**Date:** June 12, 2015  
**File #:** 13 - 252825  
**Folder Name:** 1052 ROSS AVE  
**PIN:** 282922340015

Date: June 12, 2015  
File #: 13 - 252825  
Folder Name: 1052 ROSS AVE  
PIN: 282922340015

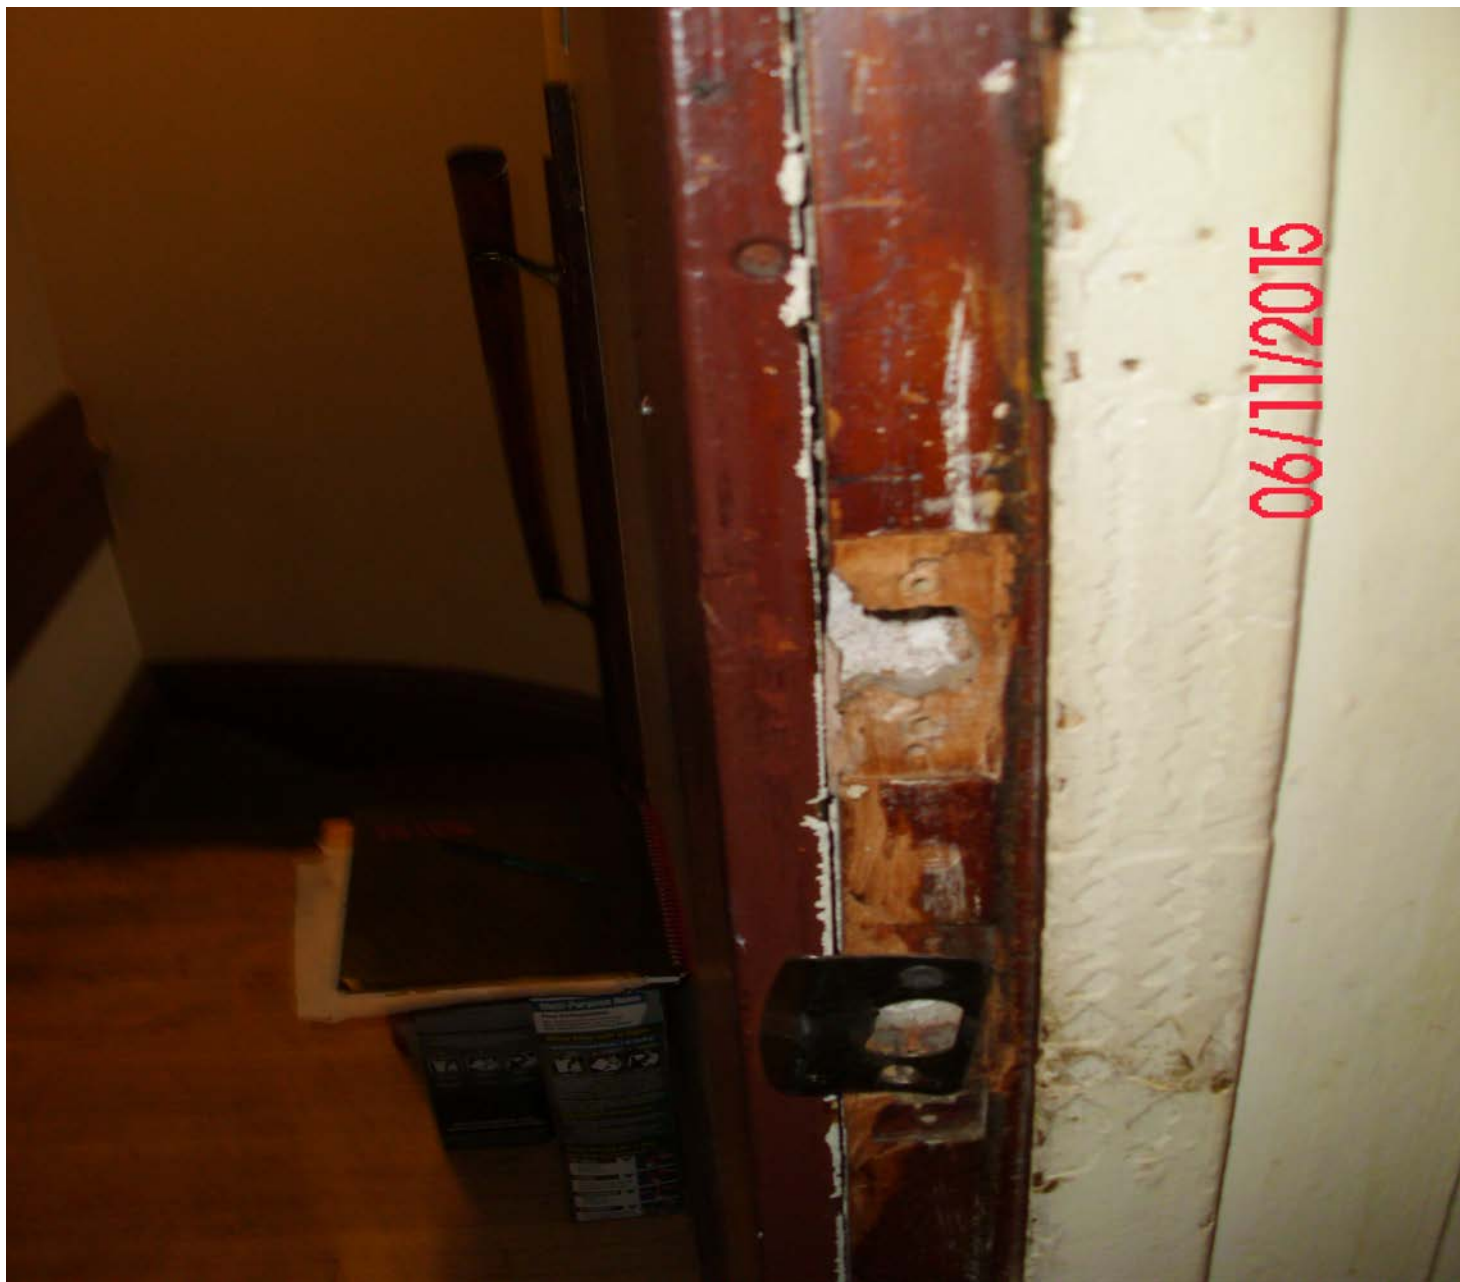
Replacement window not finished. Insulation showing at lower sash/sill
